Access Compliance Report

Public Rights-of-Way

Intersection ID: 11810	Main Street: ALLEN_ST	Cross Street: E_19TH_ST	Location: E
ADA ID: DA5892E8C51E	Ramp Type: PerpDiag	Initial Pass/Fail: Pass	Overall Compliance: No
		Severity Score: 10

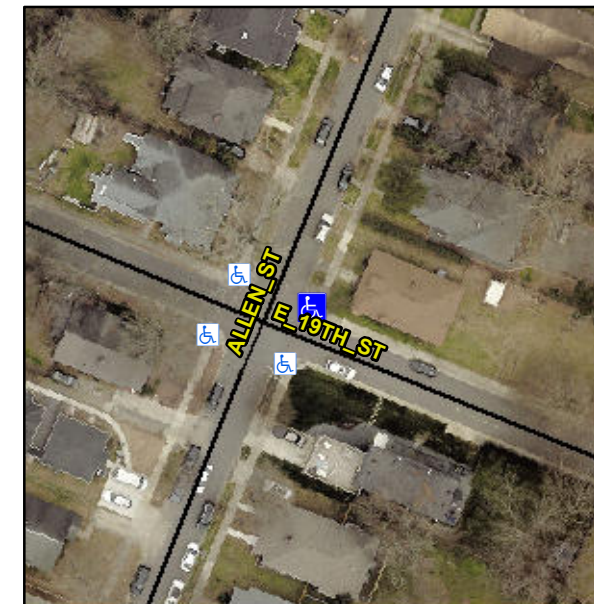
Not Found, R304.5.3, R305.1.4, R305.2, R302.7.2

Compliance	Description	Data	Compliance	Description	Data
N/A	Ramp Length (in)	50.0	Yes	Ramp Slope (%)	5.2
Yes	Ramp Width (in)	48.0	Yes	Ramp XSlope (%)	1.1
N/A	Flare Type LT	Sloped	N/A	Flare Type RT	N/A
N/A	Flare Slope LT (%)	5.7	N/A	Flare Slope RT (%)	4.4
N/A	Flare Traversable LT?	No	N/A	Flare Traversable RT?	No
Yes	Landing Length (in)	87.5	Yes	DWS Provided?	Yes
Yes	Landing Width (in)	58.5	Yes	DWS Contrast?	Yes
Yes	Landing Slope (%)	0.2	Yes	DWS Length (in)	24.0
No	Landing X Slope (%)	2.5	No	DWS Full Width?	No
N/A	Landing Curb? (Y/N)	No	No	DWS Offset (in)	3.0
N/A	Shared Landing?	No			
Yes	Gutter Ponding?	No	Yes	Gutter Slope (%)	3.0
No	Gutter Lip Ht (in)	0.5	Yes	Gutter X Slope (%)	1.1
N/A	Painted X Walk1?	No	N/A	Painted X Walk2?	No
	X Walk 1 Direction	To NW		X Walk 2 Direction	To SW
N/A	X Walk 1 Width (in)	N/A	N/A	X Walk 2 Width (in)	N/A
	X Walk 1 Slope (%)	4.1		X Walk 2 Slope (%)	1.6
	X Walk 1 X Slope (%)	2.1		X Walk 2 X Slope (%)	1.5

Remove & Replace Curb Ramp With Two New Directional Ramps or Equivalent.
